# Memorandum

Project# 270030.003

RE: McLoughlin Investments Strategy – Road Safety Audit “Lite” Summary

## ROAD SAFETY AUDIT “LITE” SUMMARY

**Alternative 1: Diagonal Bike Signal**

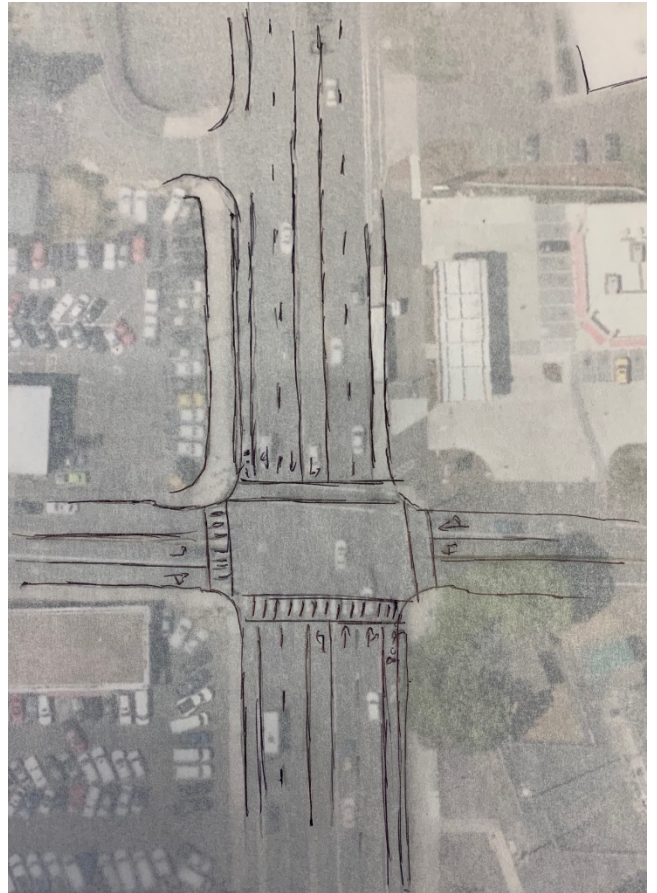
The following solutions were discussed to support people walking and biking across McLoughlin Boulevard at Jennings Avenue to make the connection to Jennings or to the Trolley Trail.

- Provide improved wayfinding to the Trolley Trail
- Install a diagonal bike signal to provide a direct route across the intersection for people biking
- Add enhanced crosswalk striping to emphasize trail connection
- Add protected intersection treatments
- Formalize the sidewalk connections for two-way biking and walking travel from the intersection to the trail

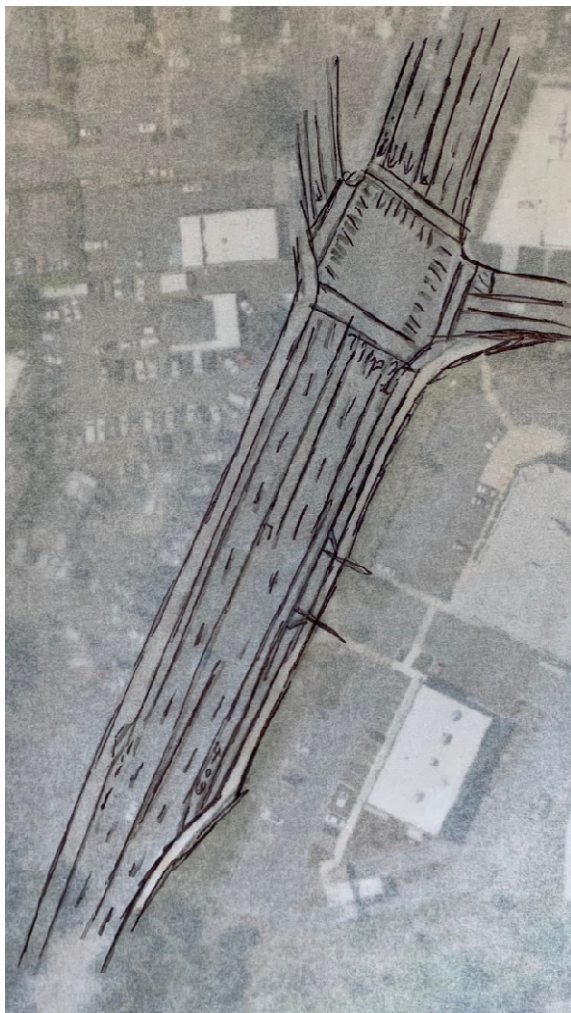
The following solutions were discussed to address issues approaching and along the Clackamas River Bridge along the corridor:

- Extra delineation for bike ramp onto bridge and additional signage to indicate that bicyclists may use sidewalk
- Actuated flashing “Bikes on Bridge” beacon
- Multi-use path or wide sidewalk from bridge to intersection with Arlington Street to accommodate people biking northbound or removal of the right turn lane northbound at Arlington (see below)
- Additional lighting on bridge
